Review of airport charges at Dublin Airport

Review of Capital Programme

Commission for Aviation Regulation

28 September 2005

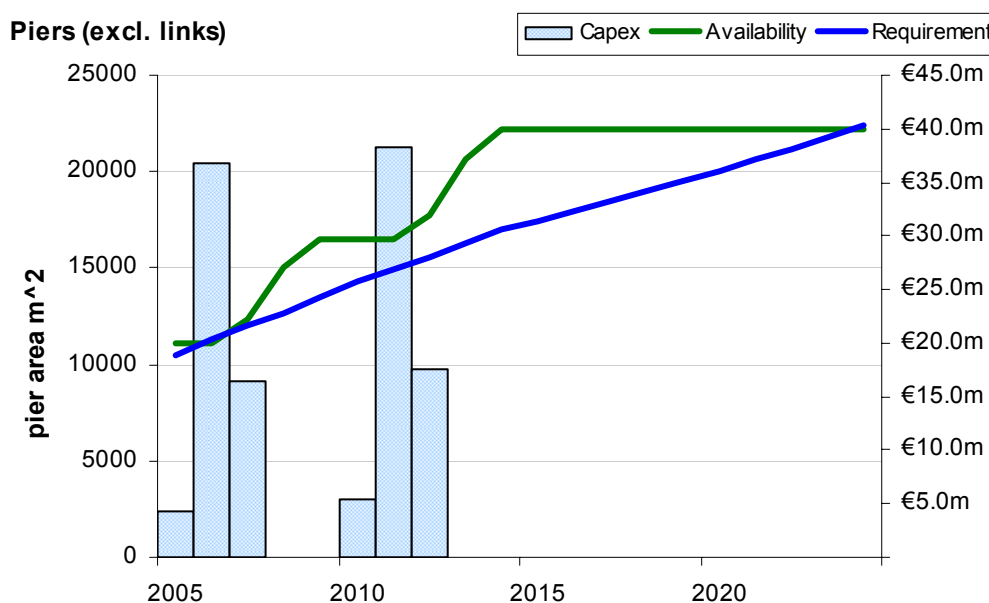
The following graph shows the implied pattern of increasing pier capacity need, driven by growth in passenger flows within the airport as a whole, and the increase in pier provision caused by the CIP proposals for piers D and E:

The graph illustrates that the proposed timing of the piers (with Pier E being fully operational in 2013) appears reasonable. This suggests that DAA's scheduling of these investments in the CIP is broadly consistent with our assessment of BHFR capacities.

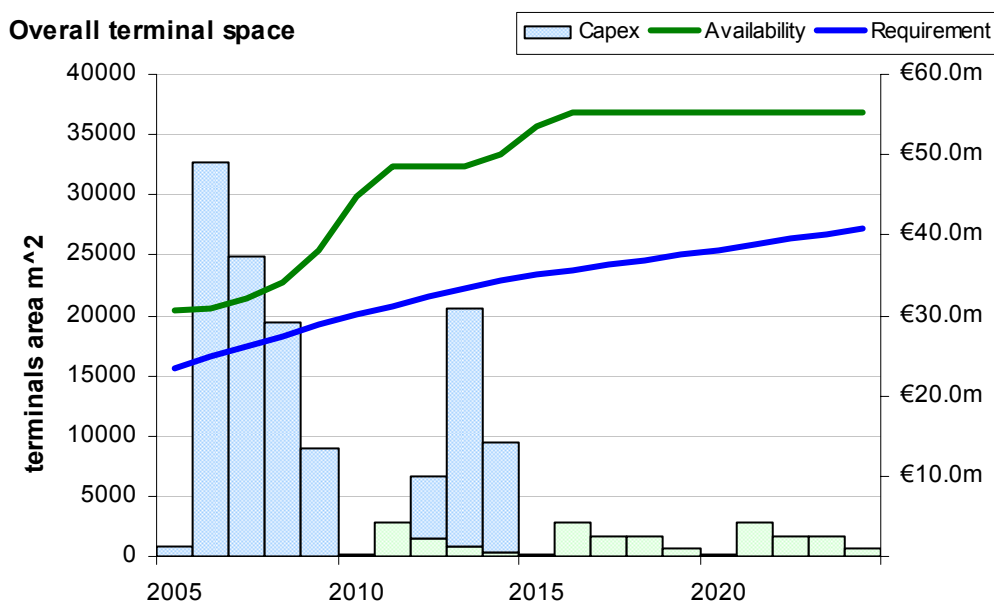
The following graph relates the proposed capacity increments to projected capacity requirements. The space requirement calculations going forward include no assumptions about more efficient use of space except for an assumption of some increase in the use of self-service kiosks.

- Total terminal space available to passengers, at about 20,400m² represents significant apparent headroom over the aggregate assessed requirement for passenger space of some 14,600m² – this apparent headroom is projected to be inadequate at around the time that T2 is intended to be completed;

- Meanwhile, DAA proposes to complete a significant de-bottlenecking extension by 2008 to the north of the existing terminal of more than 5,000m², of which we assess some 2,200m² should be available for passengers (see further discussion on this project below) – on the face of it, this would appear to defer the need for further terminal capacity to about 2015;

- However, viewing headroom in aggregate overlooks the fact that there is very little assessed headroom in some of the components of terminal capacity – it is clear that some terminal areas will become critically overcrowded in the short term;

- The need for an additional extension to T2, projected to be completed by 2015, is not apparent from the graph.

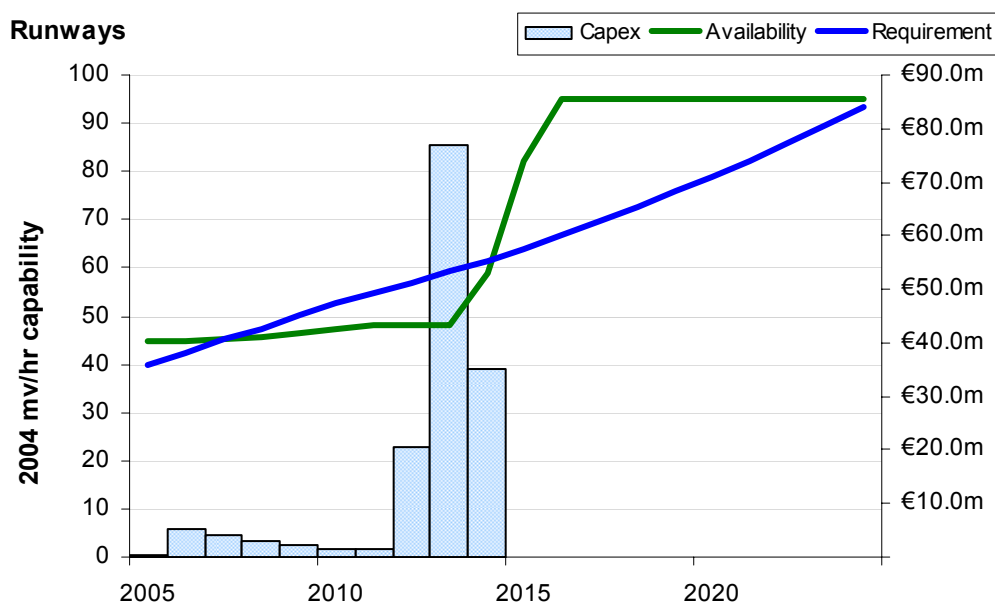
However, it is revealing to see what lies behind this analysis. A critical assumption is the relationship between passenger numbers and aircraft movements. Implicit in DAA's aircraft movements projections is an underlying increase in the number of passengers per movement of some 2.25% per annum. This may not seem a large number by itself, but the following graph shows what the impact would be if the relationship remained stable:

This example helps to highlight how sensitive capacity projections can be to relatively low level changes in utilisation, whether due to technology, more efficient management, intelligent facility design, changing usage patterns or any other factor. Changes in utilisation could potentially affect all components of capacity, and this insight may have an important bearing on the focus of an incentive regime intended to encourage efficient development of the airport – it is not necessarily just about efficient expenditure.

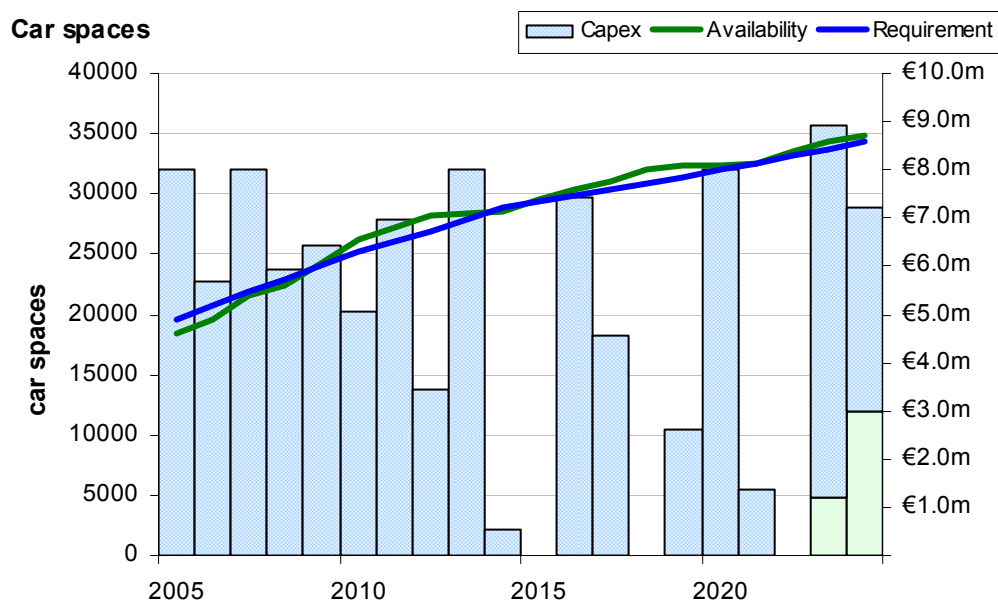
From RR&V's assessment of CIP 1.6, we might suppose a standard unit cost of some €15,000 per space for short-term (multi-storey) car parking. Recognising that surface car parks are cheaper to build, we have carried out projections of the cost of building car parks using an indicative average cost of €5,500 per space based on the assessed percentage split requirement for short-term (multi-storey) and long-term (surface) car parking (at approximately €4,000 per space for surface car parking), to generate the following graph:

These projections suggest a significant level of required spend, amounting to about €53 million to DAA's planning horizon of 2014.
